5TH AND VIRGINIA

Proposed MUP #3018037

# SECTION 02. RESPONSE TO EDG

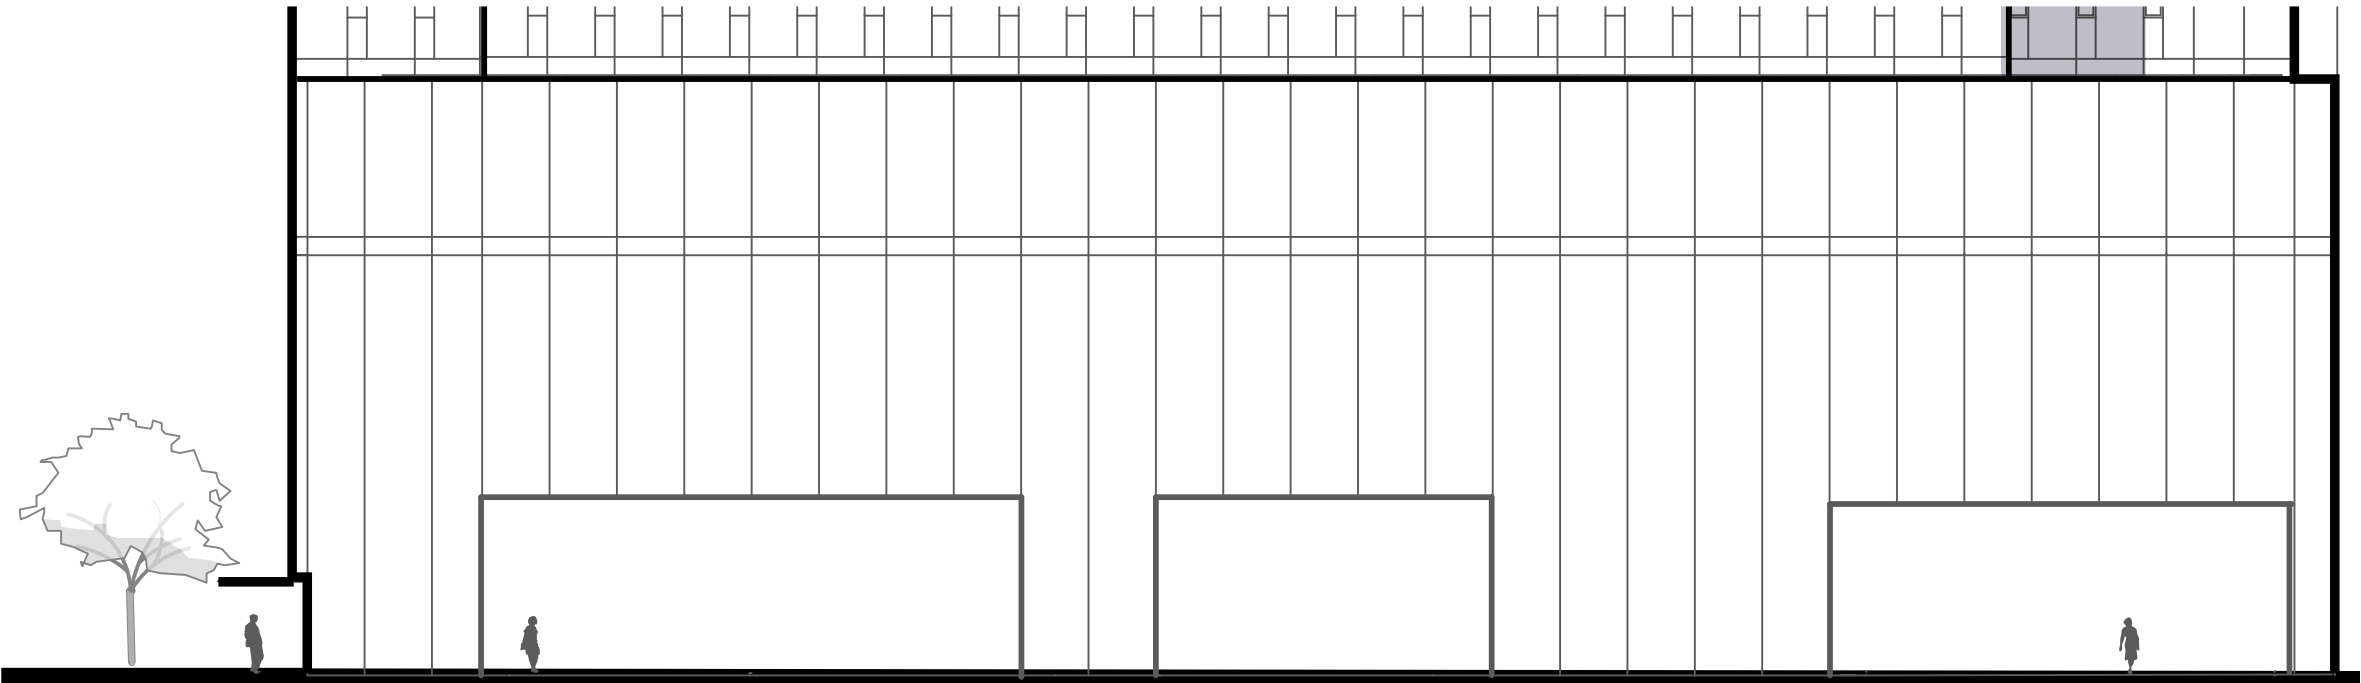
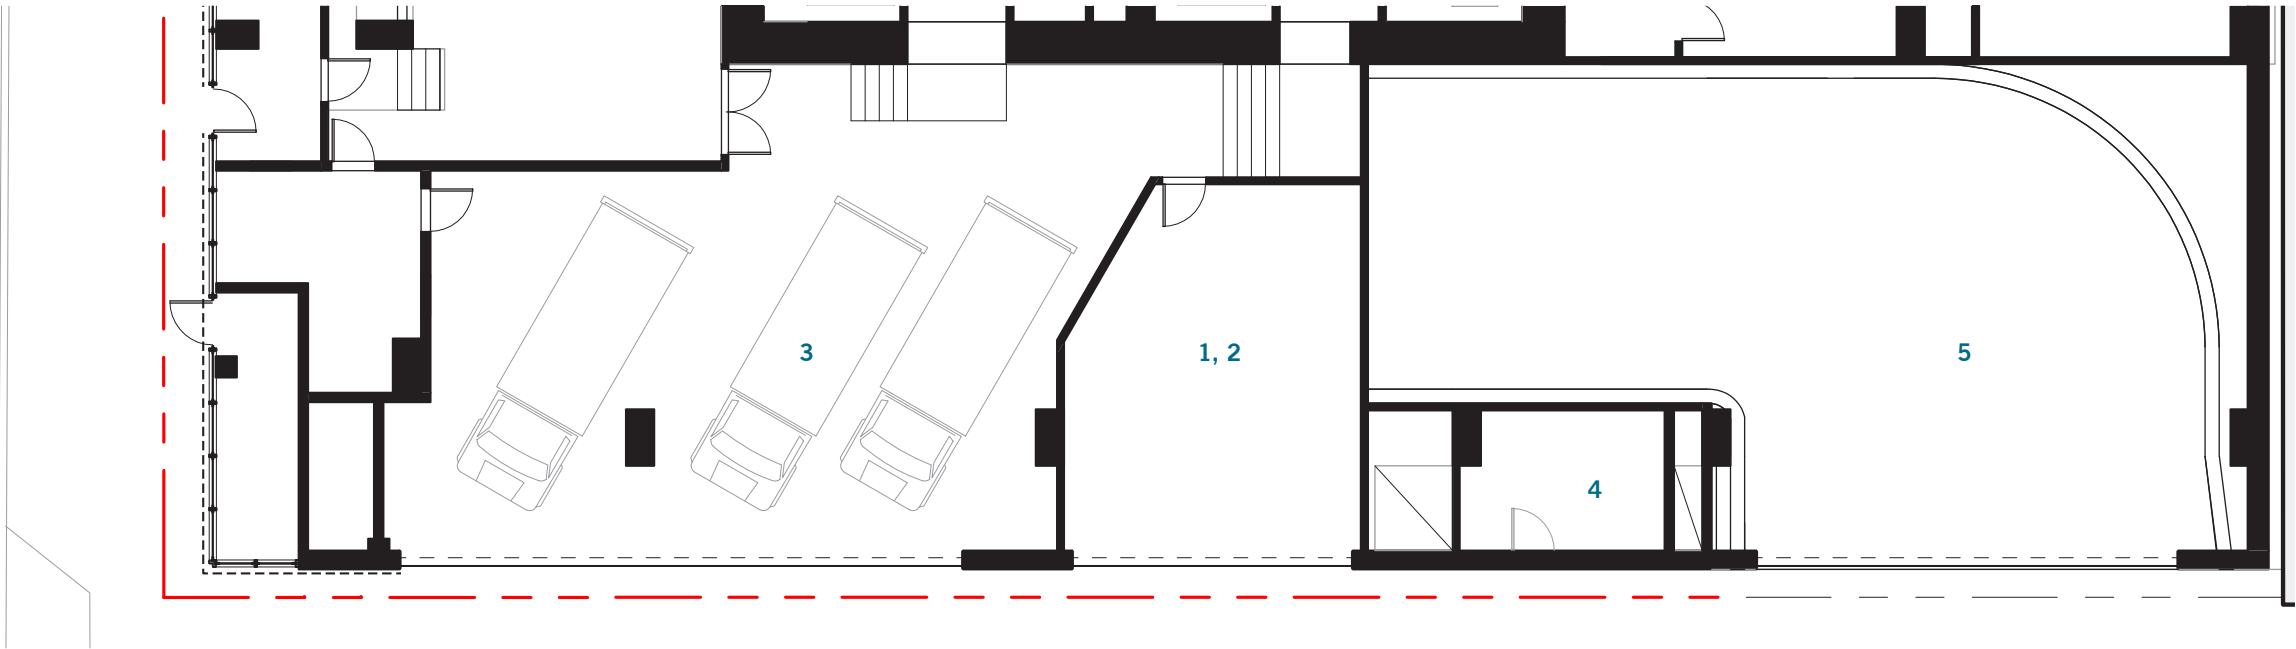
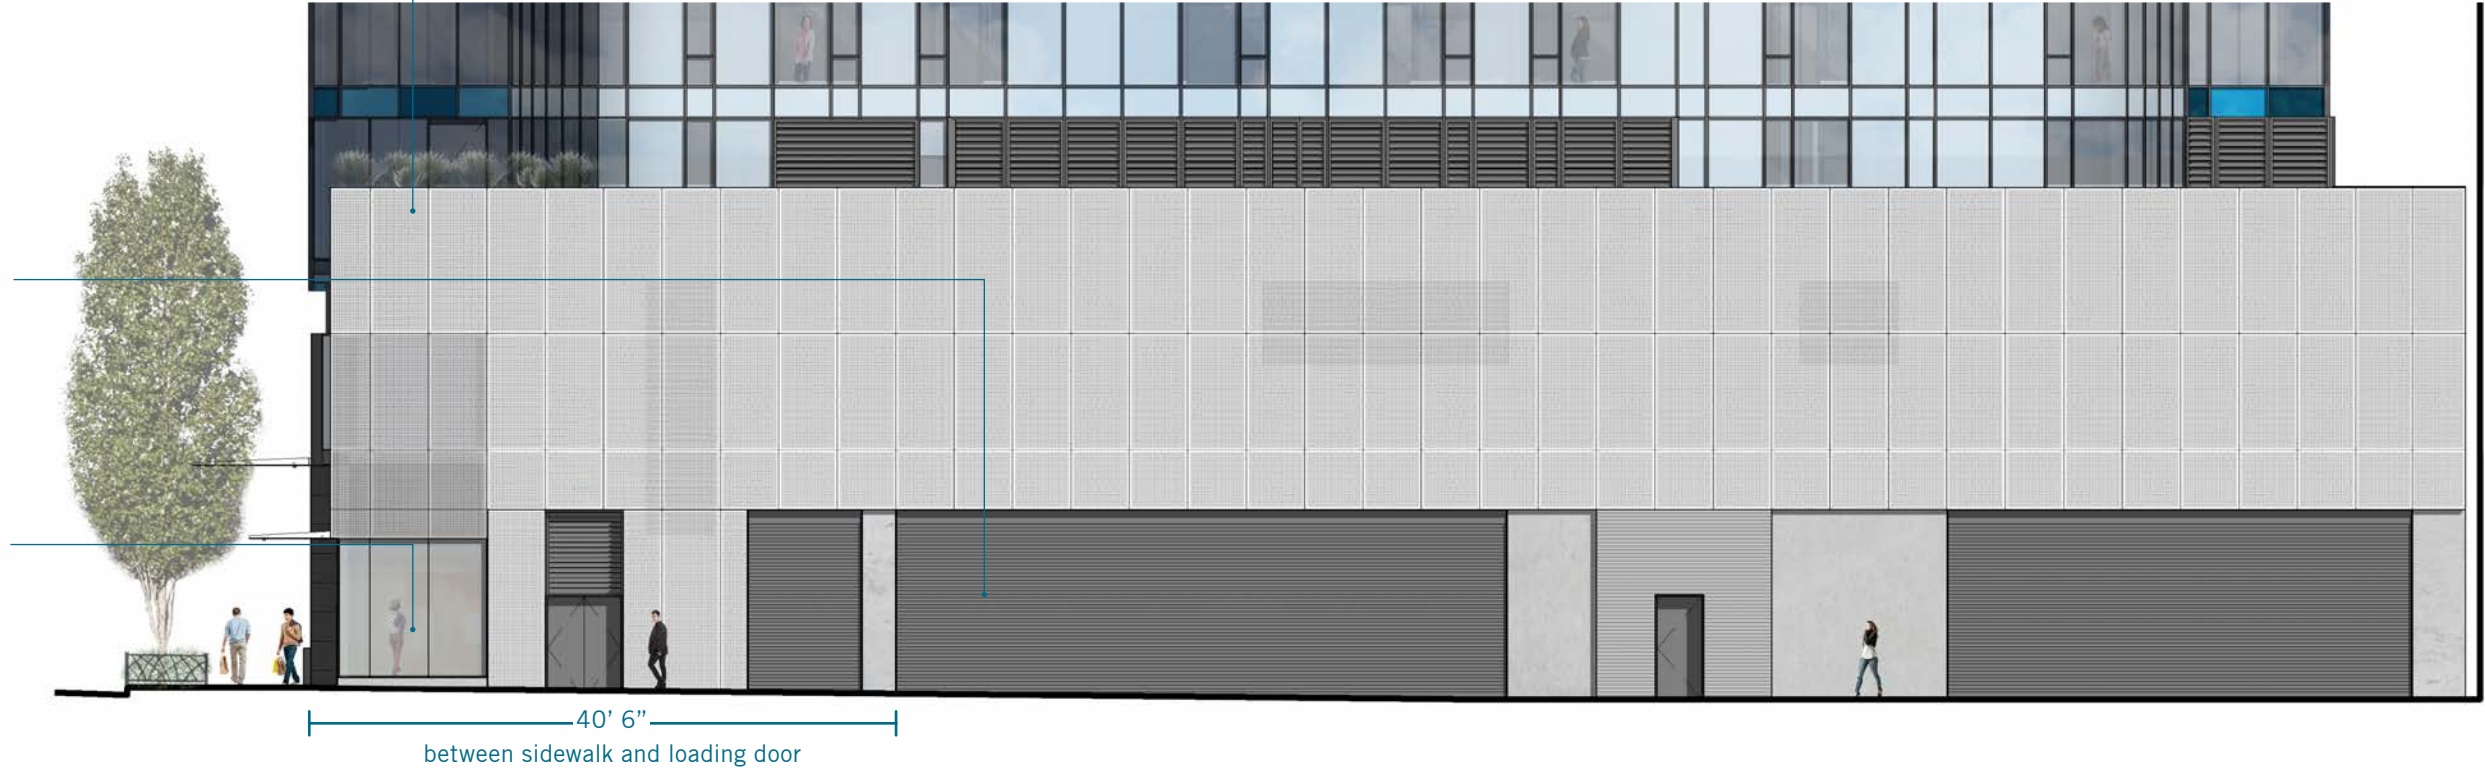
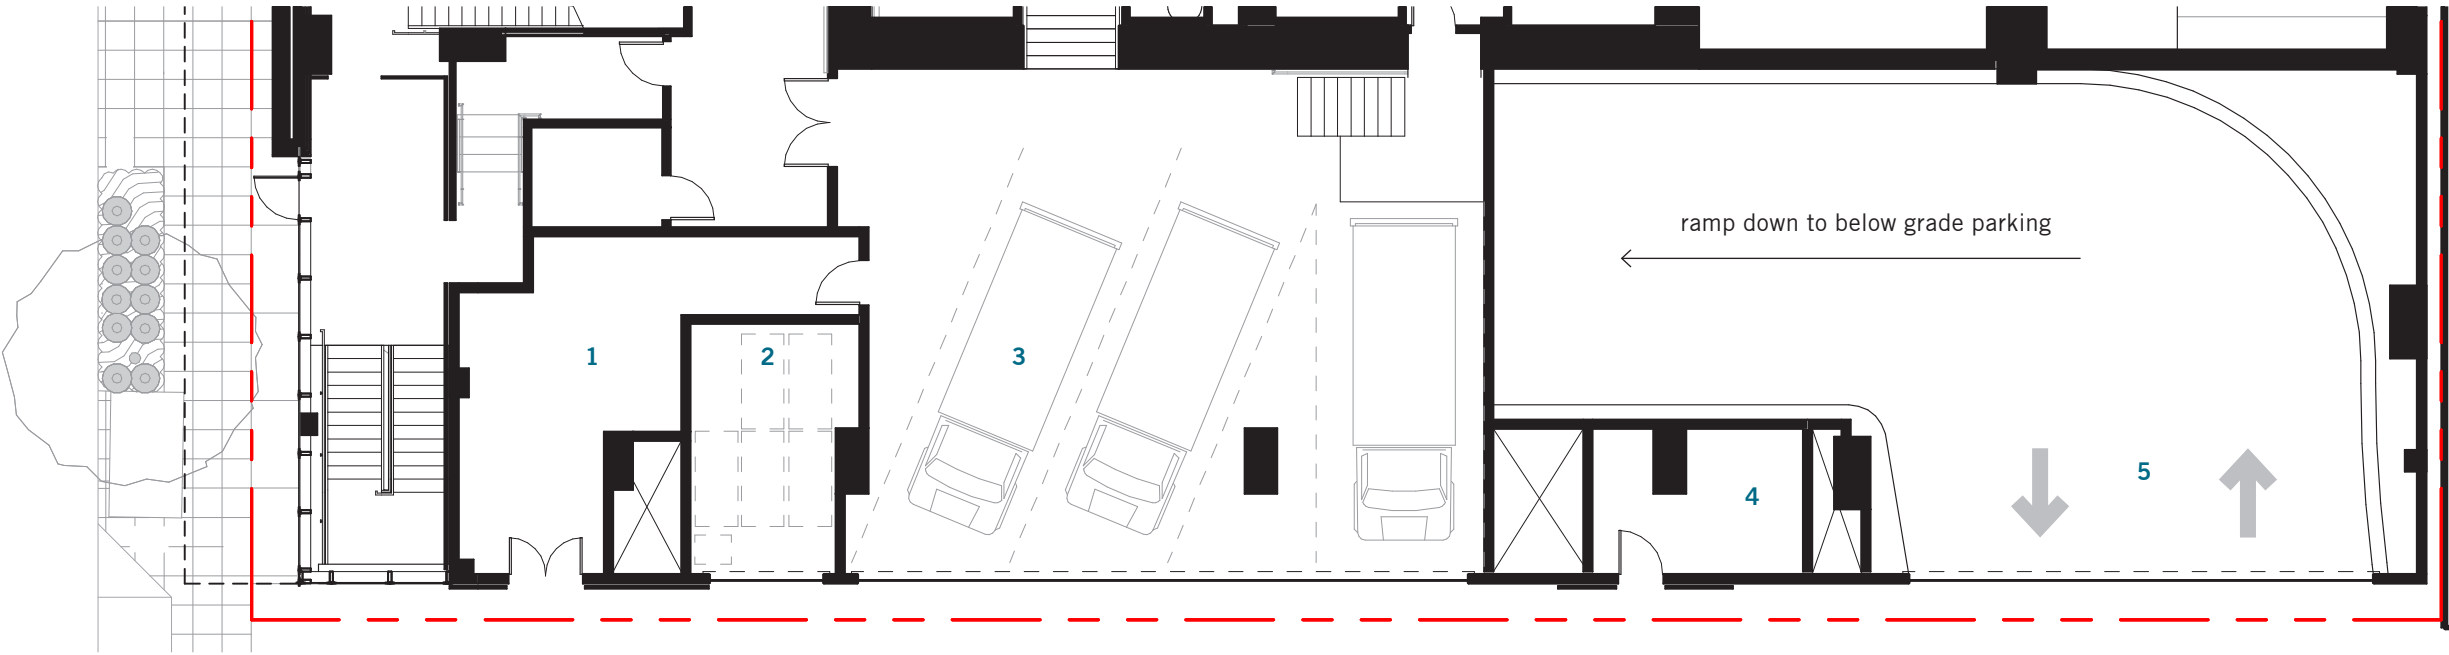
The Board agreed the loading dock door/opening is much too visible to Virginia Street, as shown on pg 60, and recommended the door be shifted at least one truck bay south.

If the trash room then occupies that location, its door should face into the loading bay or the trash door must be fully integrated into the elevation design; this visible corner deserves an architecturally sophisticated design like any other façade. (C6, C6.I, E3)

Relocated loading area further from Virginia sidewalk.

Extended transparency around the corner.
